PLAN COMMISSION MEETING

CASE: PC 24-01

PETITION: Request for approval of Special Use Permit for a mixed-use development with residential units on the upper floor and a drive-through facility in a C-1 General Commercial District pursuant to Section 12-4-3:D of the Morton Grove Municipal Code with variations for front setback (12-5-6:D), side setback (12-5-6:D), bedroom mix (12-5-6:F), signage (10-10), and select landscaping requirements (12-11) for the property commonly known as 6724 Dempster Street (PIN 10-18-400-048-0000, 10-18-400-056-0000, 10-18-400-061-0000, 10-18-400-062-0000) in Morton Grove, Illinois. The applicant is 6724 Dempster LLC.

Re: Plan Commission Case PC 24-01

SOUTH ELEVATION
SCALE: 1/8" = 1'-0"
A-4

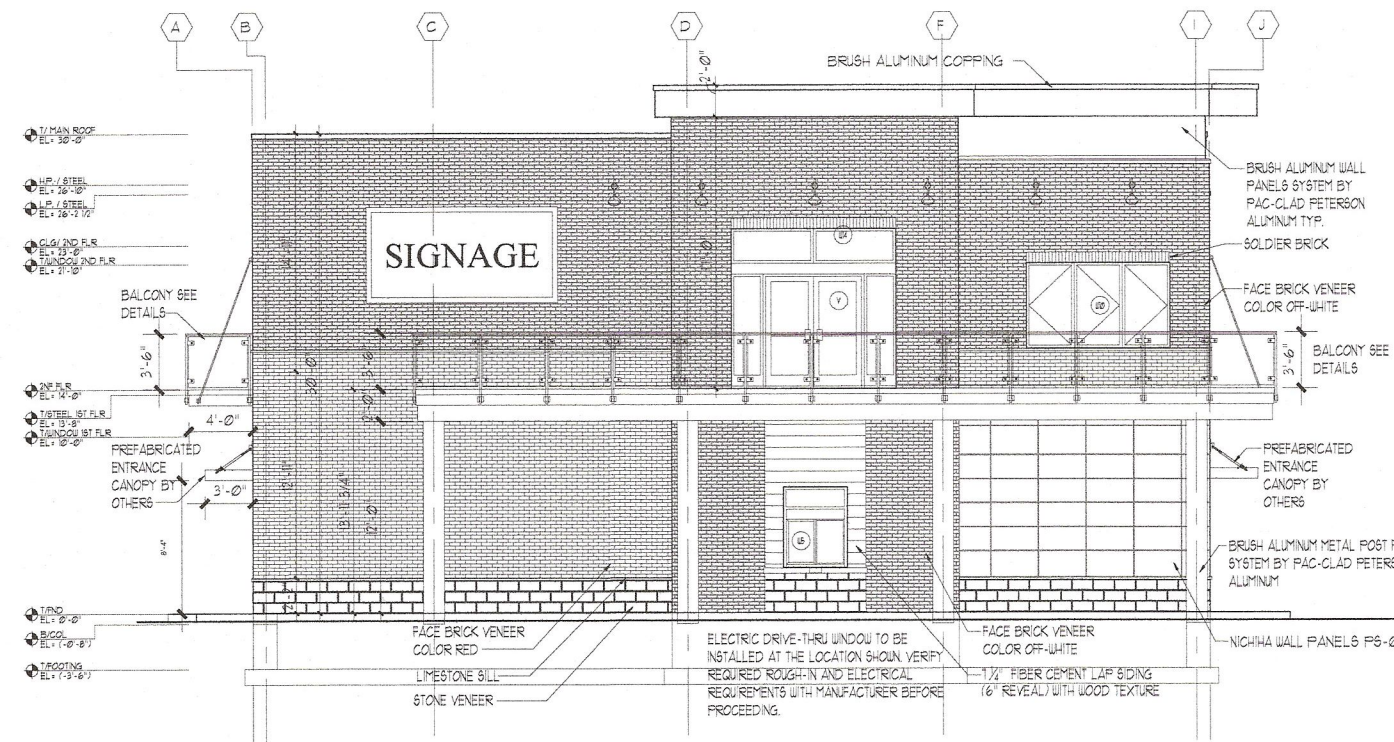
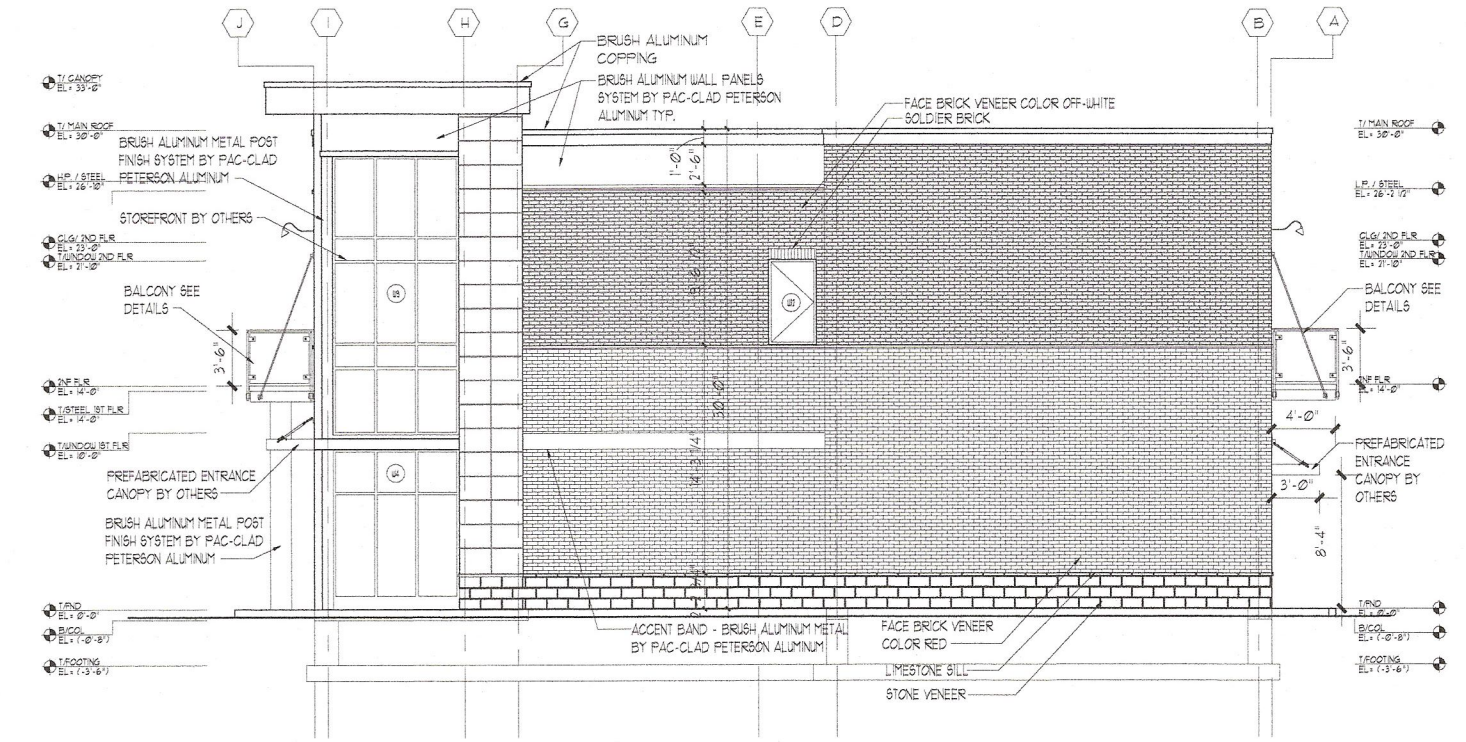
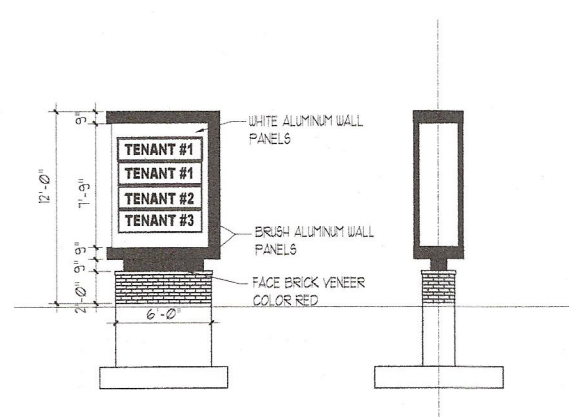
- Confirm number, size, and location of residence balconies. The application elevations show three balconies on the north wall, three balconies on the south wall, and a balcony spanning most of the west wall. The renderings show no balconies on either the north or south walls and a smaller west balcony centered above the first-floor drive through window.
- Identify window treatments and frame materials and color.
- Identify the materials, color, and finish of all wall panel locations and brick veneer.

4. *The applicant shall submit a final materials palette that aligns with and clarifies the submitted materials along with revised elevation drawings for review and approval by the Community Development Administrator. The applicant shall ensure that the elevation drawings in the formal application represent the proposed project. The following items must be addressed at a minimum:*

- *Confirm number, size, and location of residence balconies. The application elevations show three balconies on the north wall, three balconies on the south wall, and a balcony spanning most of the west wall. The renderings show no balconies on either the north or south walls and a smaller west balcony centered above the first-floor drive through window.*

Calculation Summary						
Label	Units	Avg	Max	Min	Avg/Min	Max/Min
CalcPts_1	Pc	2.30	4.8	0.5	4.60	9.60
PROPERTY LINE	Pc	0.35	2.5	0.0	N.A.	N.A.

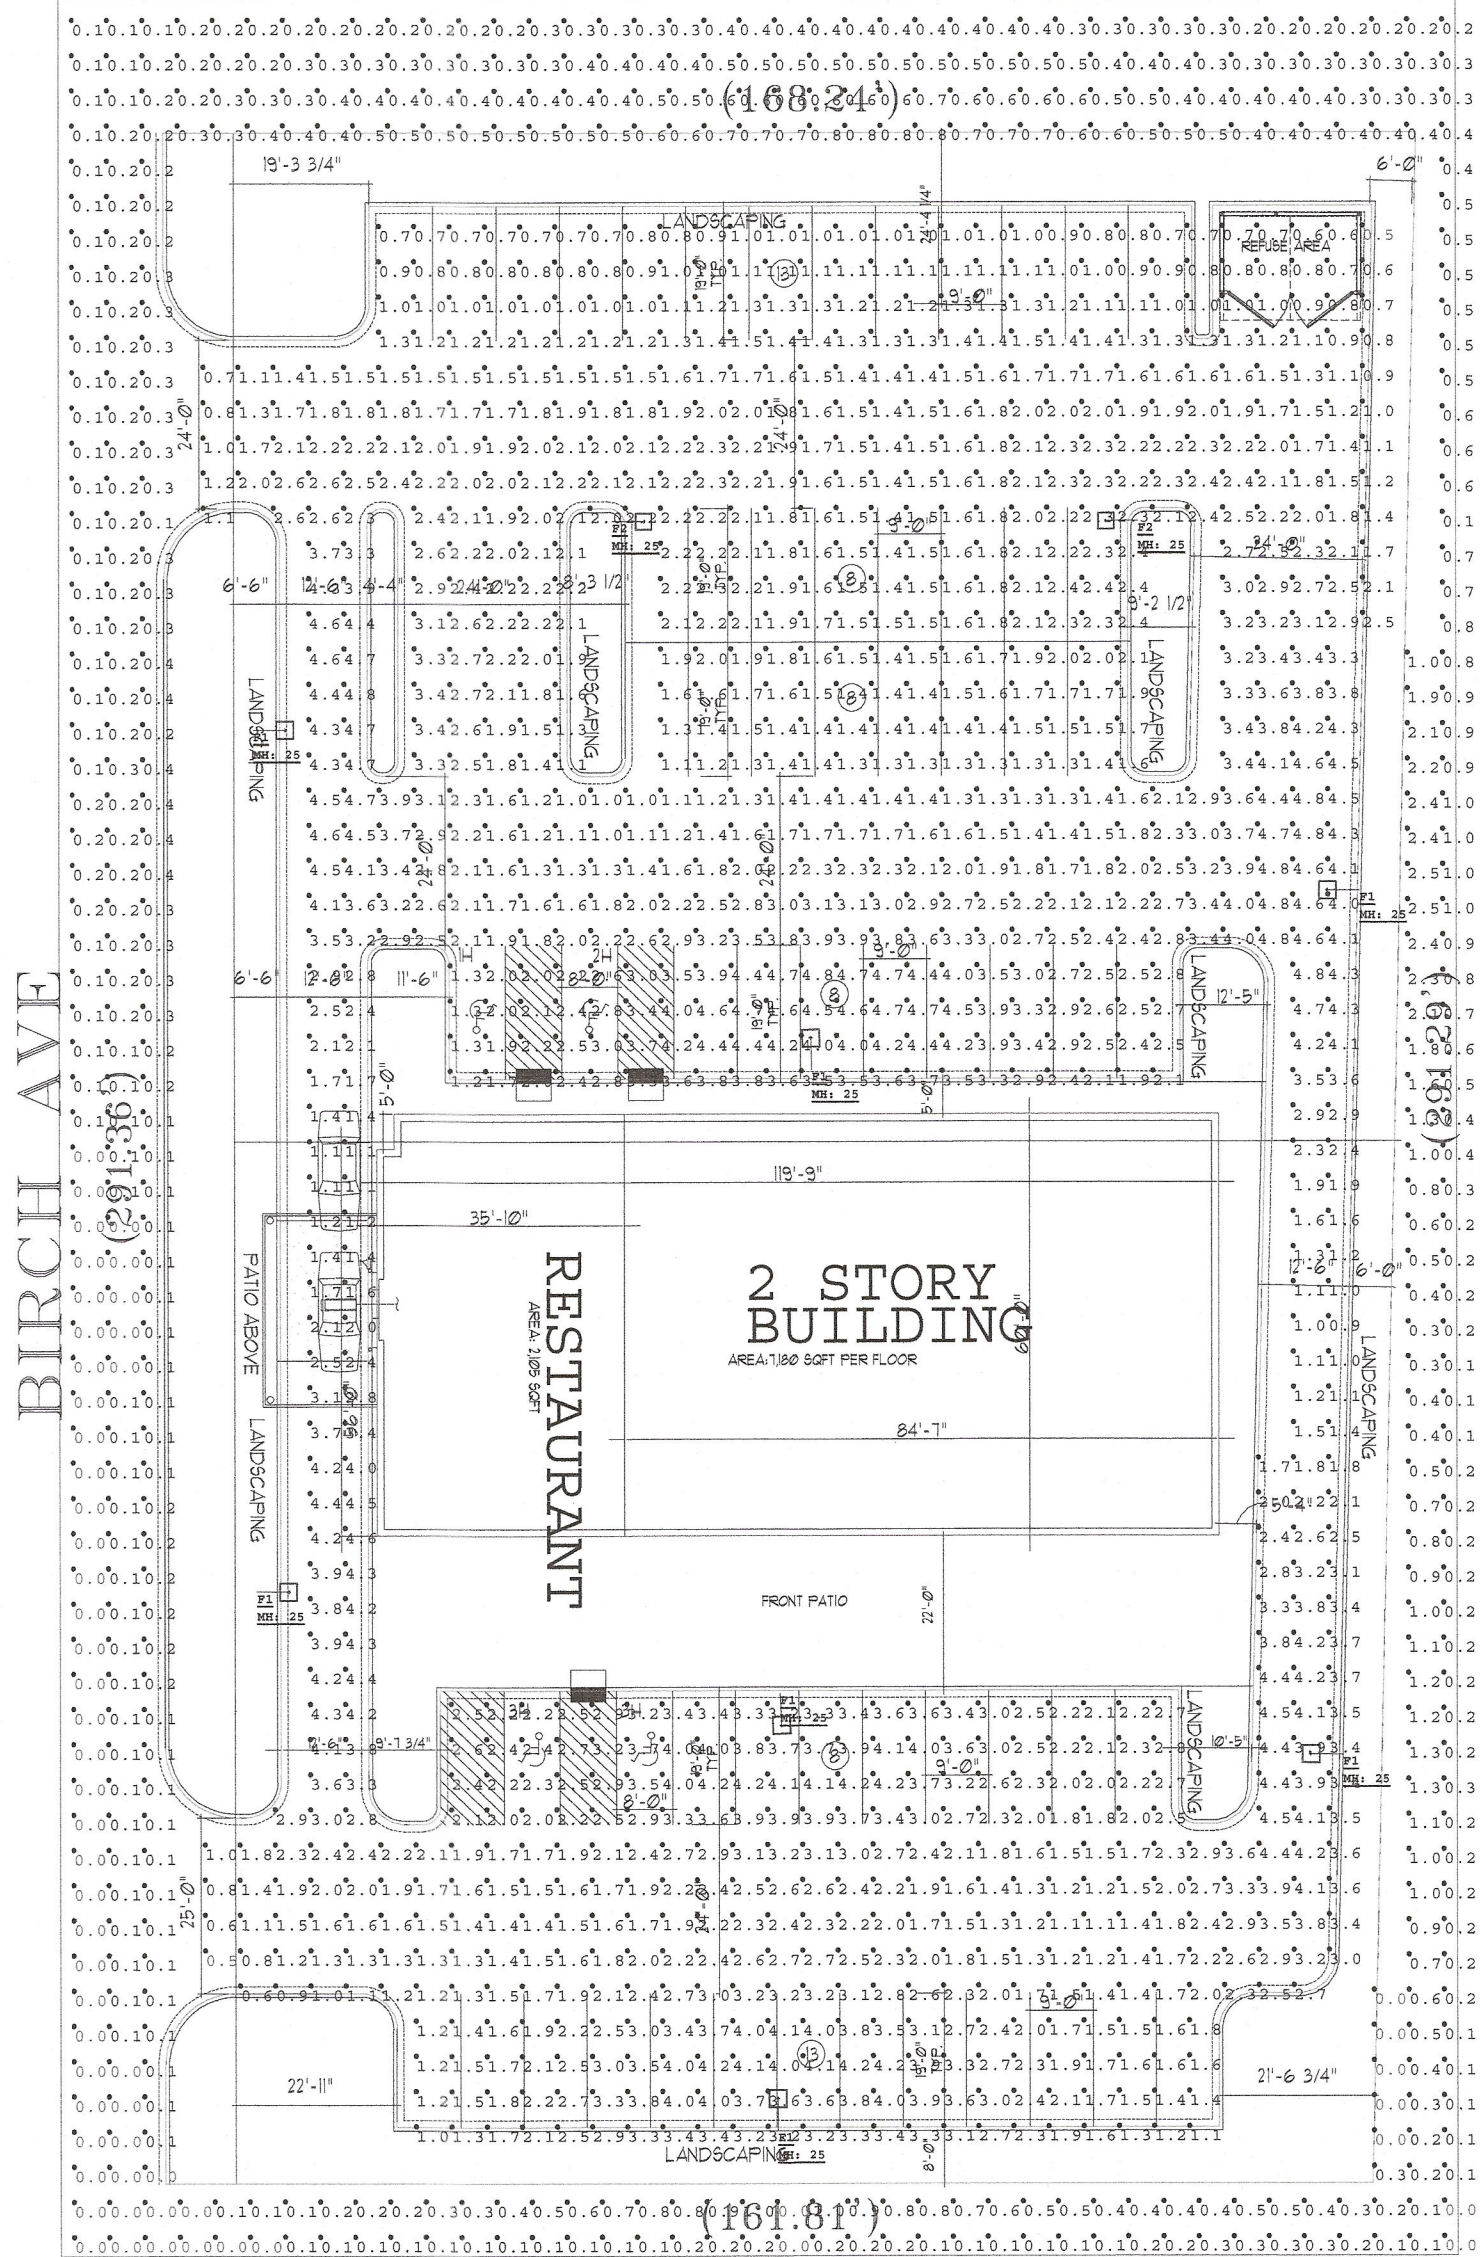
Levels along the north lot line adjacent to a residential property to the north, measure up to 0.8 foot-candles. Per Section 12-4-3.B.5, lighting of parking and loading areas must be a minimum of one foot-candle on the surface. However, such lighting must be confined to the property boundary and reach as close to zero illumination at the property boundaries as possible. Glare may not be evident from surrounding properties or adjacent public rights of way. *Staff recommends that as a condition of approval, the applicant modify the lighting plan to achieve as close to zero illumination at the northern property line, subject to review and approval by the Village Engineer.* **The applicant is expected to discuss the types of lighting fixtures proposed in the photometric plan and address concerns regarding spill over to adjacent properties.**

2. *Prior to filing any Building Permit Application, the owner/applicant shall provide the Village with a final photometric plan that meets the minimum requirements of Village Code for review and approval by the Community Development Administrator and Village Engineer.*

PROPOSED SITE PLAN

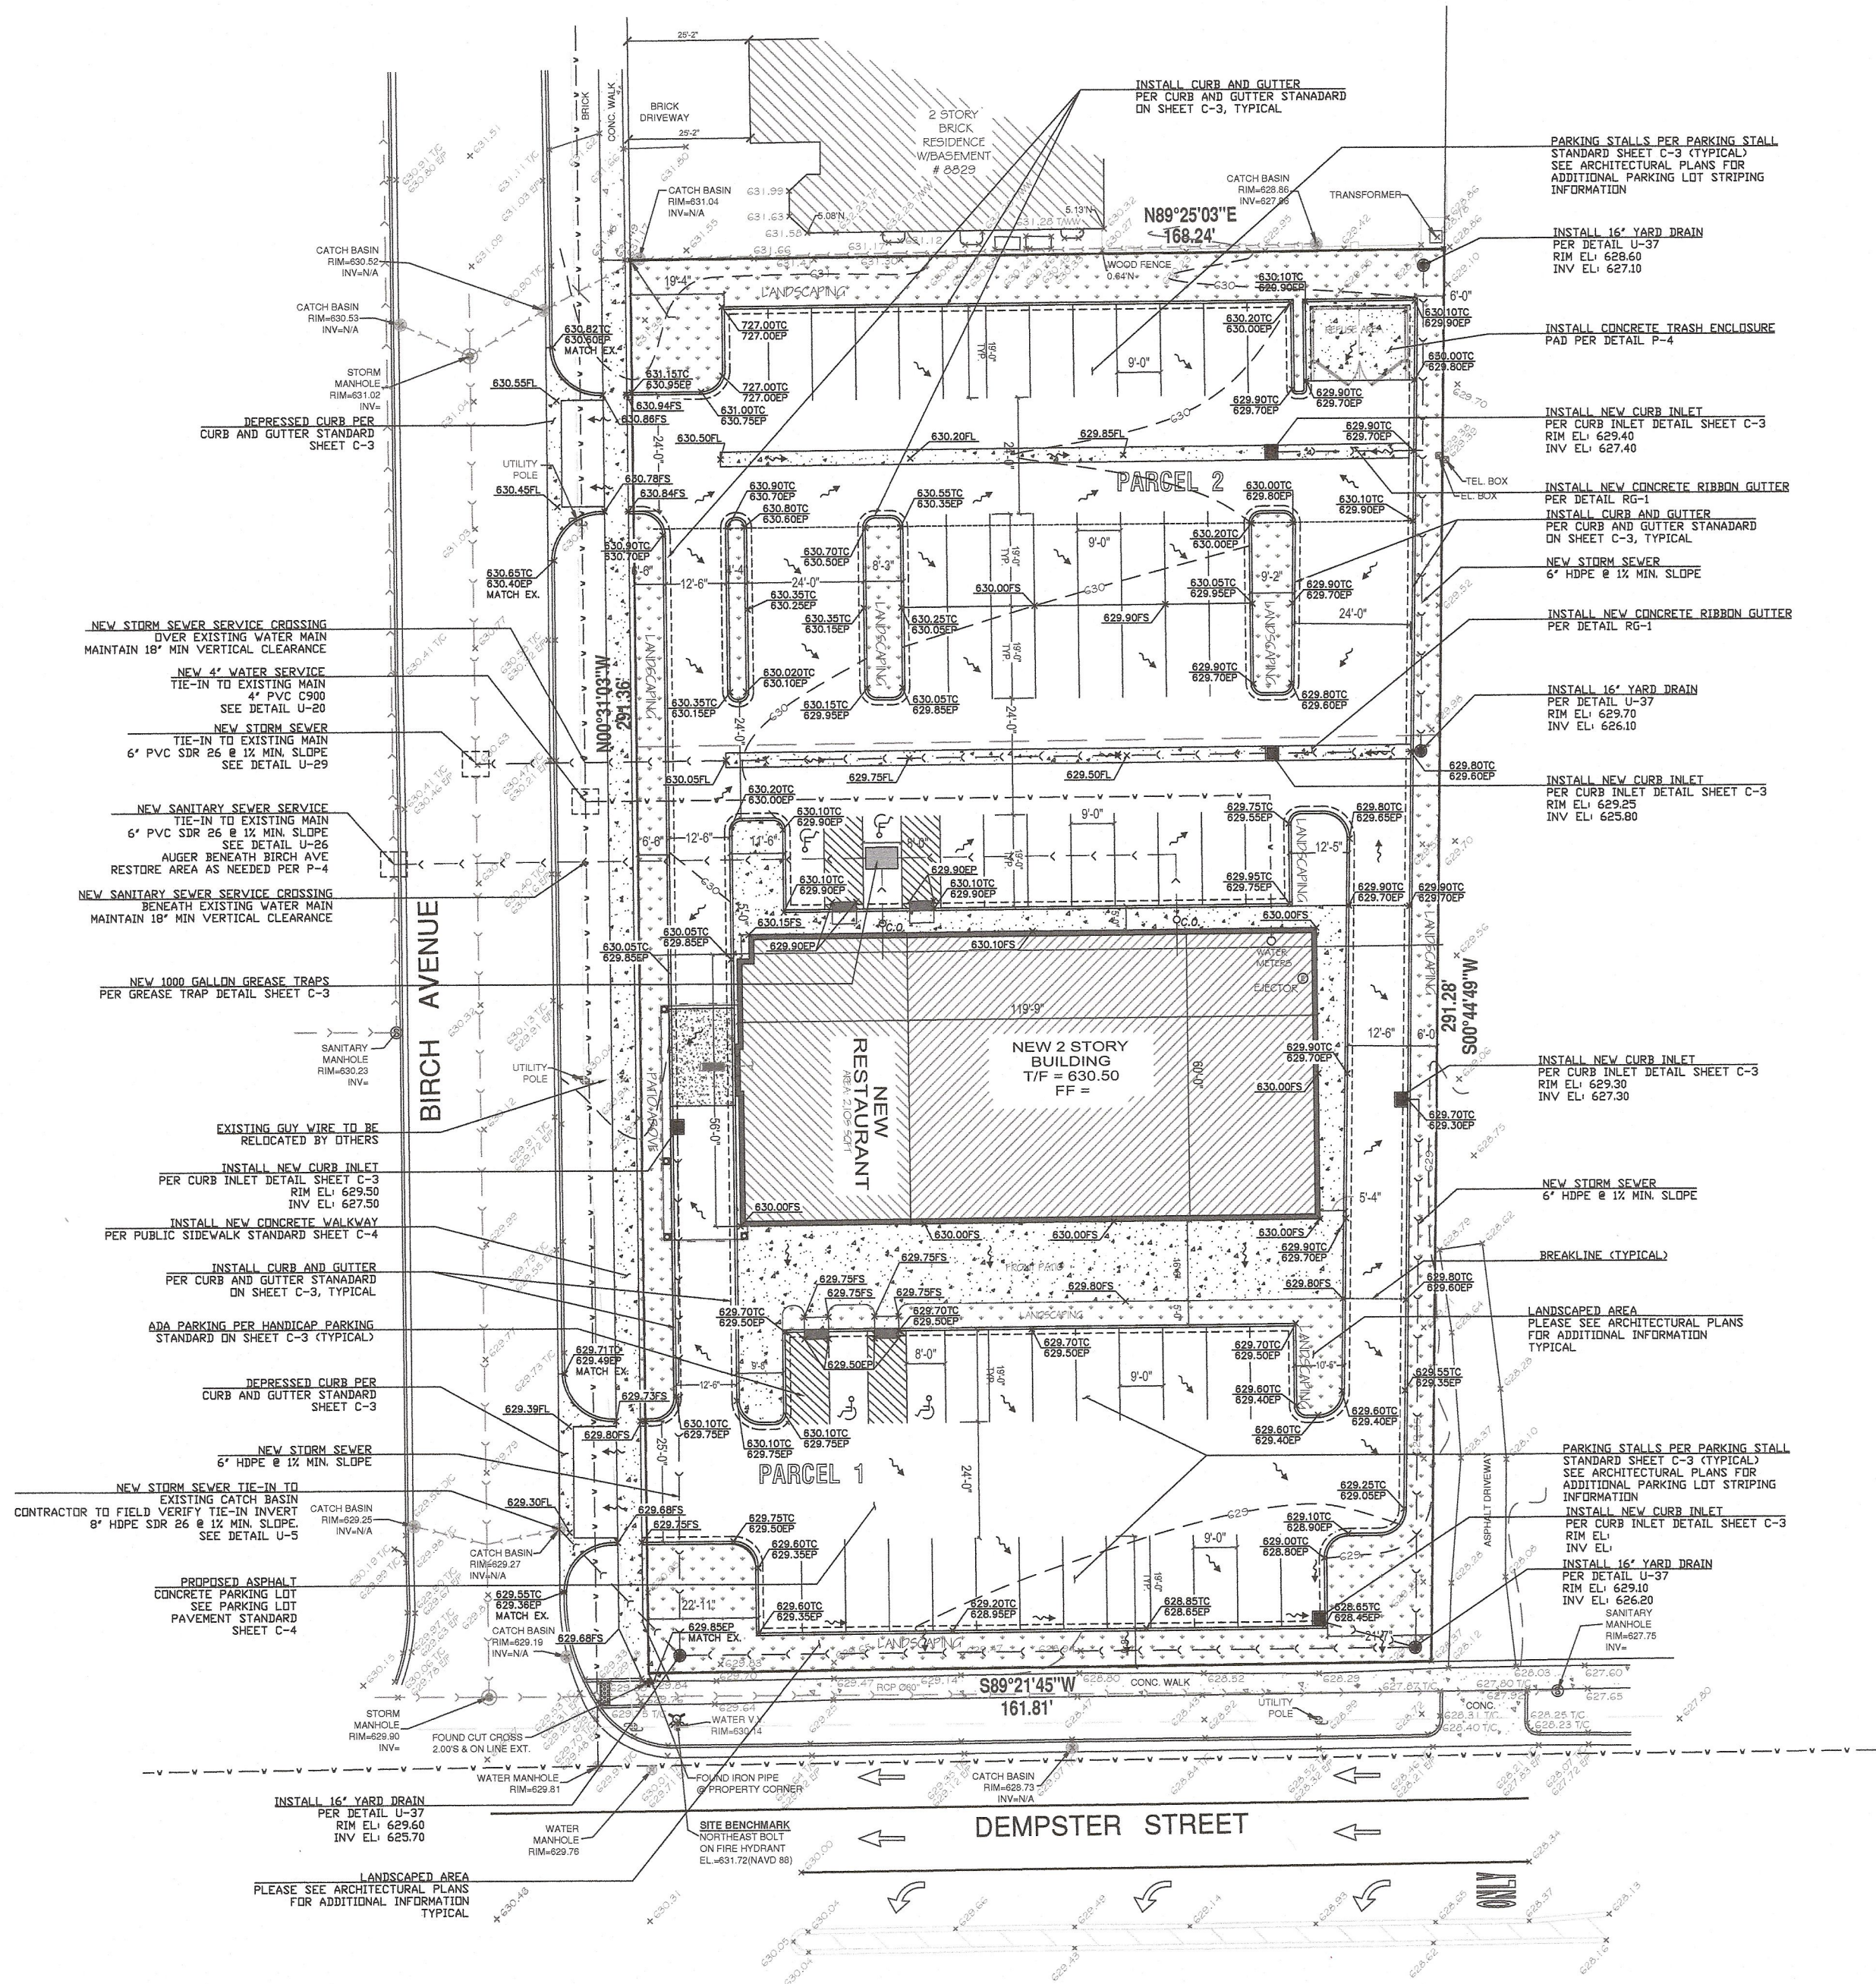
11. The plans include a proposed stormwater management facility. However, the submittal is inadequate for analyzing what would be required, only what is provided. Additionally, the stormwater management facility (underground storage) is not connected to the drainage system of the site and is proposed to flow unrestricted into the Village's storm sewer, which would not be permitted. A report will be required describing, in detail, the existing and proposed drainage patterns.

13. The drainage from the property to the north should be directed over the northern curb. It appears from the landscaping plan that it will not be practical to construct a drainage path to a proposed catch basin at the northeast corner of the site.

14. The storm sewer system along the west property line is not compatible with the proposed landscaping plan.
15. Traffic Impact Study Part II Commercial Access 2nd bullet point – The reference to Birch Avenue would seem to correctly refer to Commercial Access.
